**SUNDRY NOTICES AND REPORTS ON WELLS**  
*Do not use this form for proposals to drill or to re-enter an abandoned well. Use form 3160-3 (APD) for such proposals.***SUBMIT IN TRIPLICATE - Other instructions on page 2****HOBBS OCD****DEC 11 2017****RECEIVED**

7. If Unit or CA Agreement, Name and or No.  
NMNM1170358. Well Name and No.  
CODORNIZ 28 FEDERAL 29. API Well No.  
30-025-3619610. Field and Pool or Exploratory Area  
MORROW11. County or Parish, State  
LEA COUNTY NM

CHEVRON USA INC IS REQUESTING TO RECOMPLETE THE ABOVE SUBJECT WELL. THE WELL IS IN THE MORROW FORMATION AND WILL NOW BE IN THE DELAWARE FORMATION WITH THE NEW FOLLOWING PROCEDURE:

Codorniz 28 Federal 2  
30-025-36196  
Chevron USA Inc  
December 07, 2016  
Conditions of Approval

**Proposed WBD**

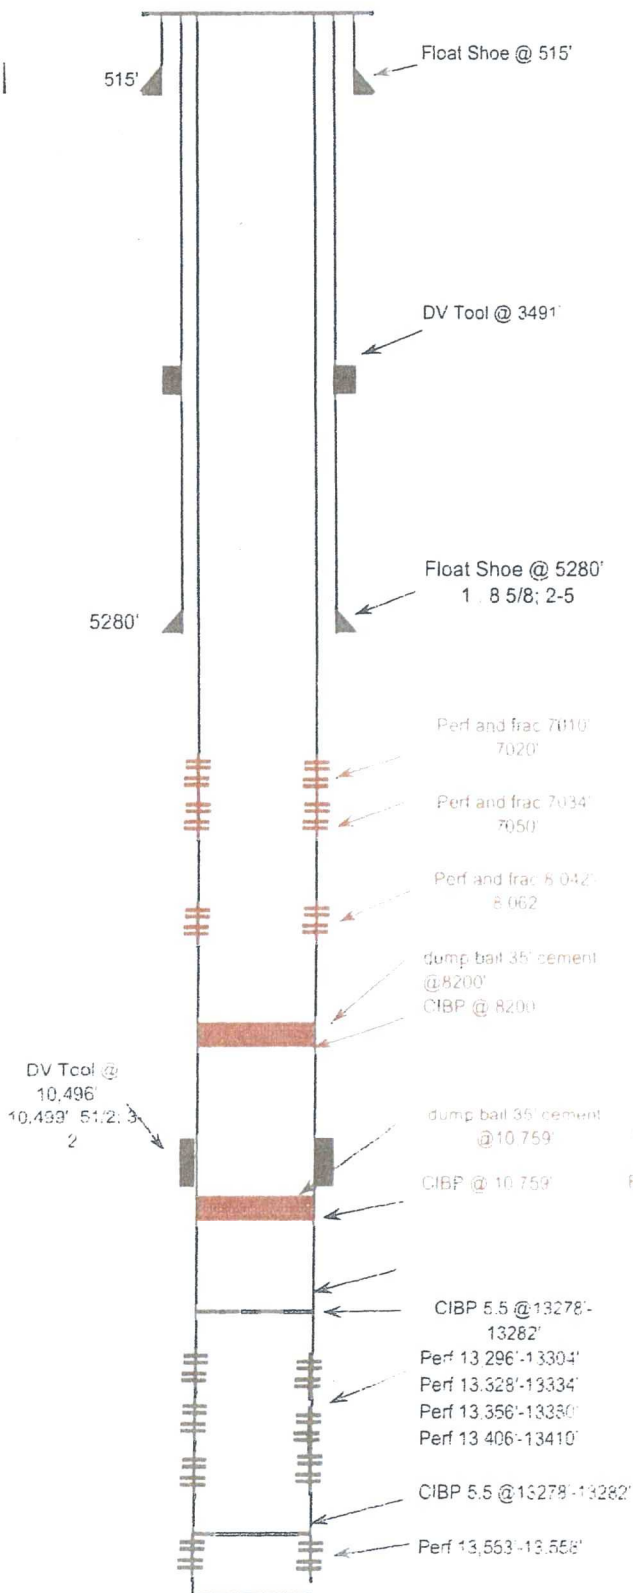
MIRU N/U BOPE AND TEST  
TOOH WITH EXISTING TUBING  
SET CIBP AT 10,759' DUMP BAIL 35' OF CEMENT (WOLF CAMP PLUG)  
SET CIBP AT 8,200' DUMP BAIL 35' OF CEMENT (BONE SPRING PLUG)  
FIRST STAGE PERF AND FRAC DELAWARE FORMATION (7010' - 7020'; 7034' - 7050')  
SECOND STAGE PERF AND FRAC DELAWARE FORMATION (8042' - 8062')  
DRILL OUT TO NEW PBD AT 8200'  
RUN IN HOLE WITH RODS AND TUBING  
N/D BOPE, N/U TREE, RDMO

PLEASE SEE ATTACHED WELL BORE DIAGRAMS OF CURRENT AND PROPOSED WELLBORE.

1. Operator shall tag CIBP at 13,278' and place 25sx Class H Cement on top. WOC and tag.
2. Operator shall place a solid Class H Cement plug from 12,890'-12,660' to seal the top of the Morrow formation.

Note: Operator may combine plug 1 and 2. Setting CIBP at 13,278' and cementing to 12,660' if desired. WOC and tag.

3. Operator shall place a solid Class H Cement plug from 10,859'-10,651' to seal the top of the Wolfcamp formation.
4. Operator shall place a solid Class H Cement plug from 10,596'-10,396' to seal the DV tool. WOC and tag.

Note: Operator may combine plug 2 and 3 to place one Class H Cement plug from 10,859'-10,396'. WOC and tag.

5. Operator shall place a solid Class H Cement plug from 8,251'-8,071' to seal the top of the Bone Spring formation.
6. Must conduct a casing integrity test before perforating and fracturing. Submit results to BLM. The CIT is to be performed on the production casing to max treating pressure. Notify BLM if test fails
7. Before casing or a liner is added or replaced, prior BLM approval of the design is required. Use notice of intent Form 3160-5.
8. Surface disturbance beyond the originally approved pad must have prior approval.
9. Closed loop system required.
